### Notice of CPU Boards Change

#### (For Use in the Hoisting Inverter of 400V class U2 series 5t and under )

Thank you for selecting a Mitsubishi hoist and related products. This letter is to notify the CPU boards change (for use in hoisting Inverter of 400v class U2 series 5T and under).

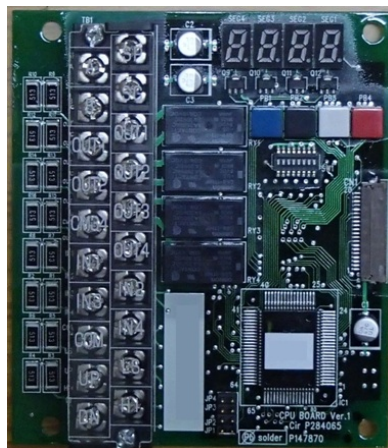
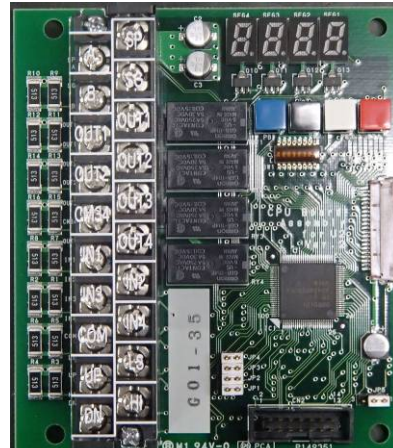
Change the CPU boards.

(1) It is possible that to set the frequency per 0.1Hz when the frequency is 10Hz and under.

(2) The improved sinusoidal modulus makes low noise.

(3) Switching product is compatible with existing product.

(4) **It is impossible that to use for concurrent usage existing CPU boards and switching CPU boards for tandem hoist operations. (There is a possibility to tilt the load)**

CPU board	Existing Product		Switching Product	
	Part Code	Drawing. No	Part Code	Drawing. No
	03G54S	P148589G01	03G54Y	PY00535G02
